# UNITED STATES PATENT AND TRADEMARK OFFICE

APPLICATION NO.	FILING DATE	FIRST NAMED INVENTOR	ATTORNEY DOCKET NO.	CONFIRMATION NO.
10/823,410	04/13/2004	Robert M.M. Haddock	50200-00056	3245
25231 7590 04/28/2009 MARSH, FISCHMANN & BREYFOGLE LLP 8055 East Tufts Avenue Suite 450 Denver, CO 80237				
EXAMINER				
GILBERT, WILLIAM V				
ART UNIT		PAPER NUMBER		
3635				
MAIL DATE		DELIVERY MODE		
04/28/2009		PAPER

### Office Action Summary

**DETAILED ACTION**

Figure 15 from Dressler

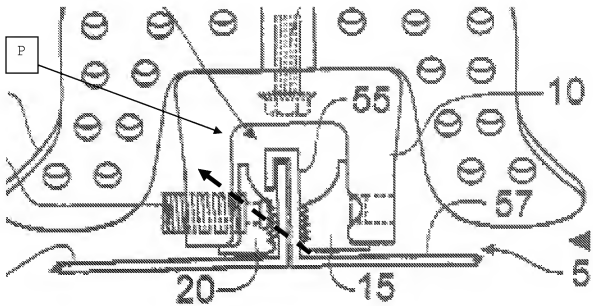
Claim 31: Dressler discloses a clamp (Fig. 1) mounted on a rib (Fig. 15), the clamp having a first clamping member (10) that engages a first sidewall of the rib (engagement does not limit the member to actual contact with the rib), the clamping member also extends beyond the first rib (portion 14b extends beyond the rib) in a direction that is away from a first reference plane that contains the first and second base section, the first clamping member comprises a mounting flange (Fig. 1: 12) in the form of a cantilever that extends away from a second reference plane that is orthogonal to the first reference plane and extends along a length dimension of the first rib, an attachment mounting fastener (50) threadably engaged with the mounting flange, a second clamping member (22) that engages the second sidewall of the rib, wherein the second clamping member extends beyond the first rib (it extends in numerous directions,

see e.g. dashed arrow from attached Fig. 15) in a direction that is away from the first reference plane that contains the first and second base sections (it is offset from the plane and, as written, the member extends in numerous directions that read on the limitation), wherein the second clamping member is a separate piece from the first clamping member, the first end of the second clamping member engages an underside of the side mounting flange, a first fastener (25) located beyond the first rib in a direction that is away from the first reference plane (it is away from the plane in that it is offset from the plane, see above for interpretation) that contains the first and second base sections that is associated with the clamping members, activation of the fastener causes the clamping members to exert an inwardly directed force on the first rib, and the first fastener lacks a nut. Dressler does not disclose the shape of the panel as claimed. Hague discloses a panel with ribs (Fig. 1: 28) and base members (proximate 26) where the ribs have first and second sidewalls (36, 38) that extend away from the base section. It would have been obvious at the time the invention was made to a person having ordinary skill in the art as a matter of duplication of parts to have this limitation because duplication of parts has no patentable significance unless a new

Claim 64: as shown, the mounting flange is spaced further from the first reference plane that contains the base sections than an uppermost extreme of the first rib.

Claim 65: as shown the mounting flange is parallel with the first reference plane.

Claim 66: as shown, the first end of the second clamping member engages the underside of the mounting flange at a location that is spaced further from the first reference plane than an uppermost extreme of the first rib ("P" below, please note that "engages" is not limited to actual contact).

Claim 67: as shown, the first fastener extends through one of the first and second clamping members and is threadably engaged with the other of the first and second clamping members.

Figure 31 from Haddock

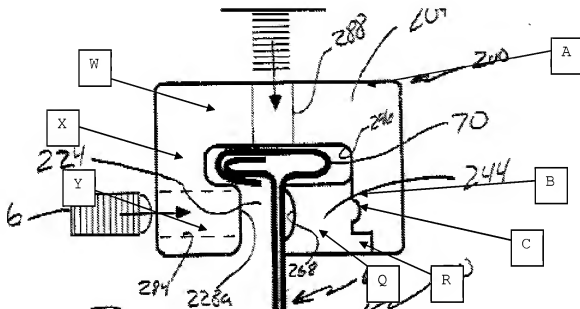
Claim 38: Haddock discloses a clamp and panel assembly comprising a panel assembly (Fig. 7c: 58) comprising a plurality of interconnected panels having base sections (58) and ribs (66) the ribs have sidewalls (proximate 66) that extend away from the base section, the sidewall has indentations (portion 66 and proximate 62 are indentations compared to portion proximate 70) and a clamp (200) mounted on a rib comprising a first clamping

member (204) that engages a first sidewall of the first rib in a direction that is away from a first reference plane (see above for the examiner's interpretation of these directional limitations) where the clamping member comprises a mounting flange ("A" above) in the form of a cantilever that extends away from a second reference plane as claimed, an attachment member (292) threadably engaged with the mounting flange, a second clamping member (244) engaging the second sidewall of the first rib and extends beyond the first rib (it extends in numerous directions, see above for the examiner's interpretation of the directional limitations), the second clamping member is a separate piece from the first clamping member and has a first end ("B" above) that engages an underside of the mounting flange and a second head (268) disposed in the second indentation and a first fastener (276) located beyond the first rib (horizontally) associated with the first and second clamping members (the limitation "associated" does not mean actual contact under the broadest reasonable interpretation) and is in addition to the attachment mounting fastener, wherein activation of the first fastener causes the clamping members to exert at least an inwardly-directed force on the first rib.

portions and the limitations of the ribs as claimed, though it does disclose the sidewalls are non-parallel (portion 70 is not parallel to portion indicated by 66) and the second side wall has an indentation (proximate 66 is an indentation in relation to portion 70). Hague discloses a panel with a plurality of ribs (Fig. 1: 28) and base members (proximate 26) where the ribs have first and second sidewalls (36, 38) that extend away from the base section in a non-parallel relation and further has a second indentation (42). It would have been obvious at the time the invention was made to a person having ordinary skill in the art as a matter of duplication of parts to have this limitation because duplication of parts has no patentable significance unless a new and unexpected result is produced. *In re Harza*, 274 F.2d 669 (CCPA 1960). See MPEP §2144.04.

Claim 41: the first sidewall has a first indentation (Haddock: proximate 66 and Hague: proximate 48) on the exterior surface of the first rib and the clamp has a first head (Haddock: proximate 228a) that is disposed in the indentation.

Claim 45: the underside of the mounting flange of the first clamping member has a recess ("C" above) that is concave and

arcuately shaped, and the first end of the second clamping member is convex and arcuately shaped (proximate "C") and is disposed in the recess of the first clamping member where activation of the first member causes the second member to move relative to the first clamping member at least generally about the first projection (activation of member 276 would cause this action.)
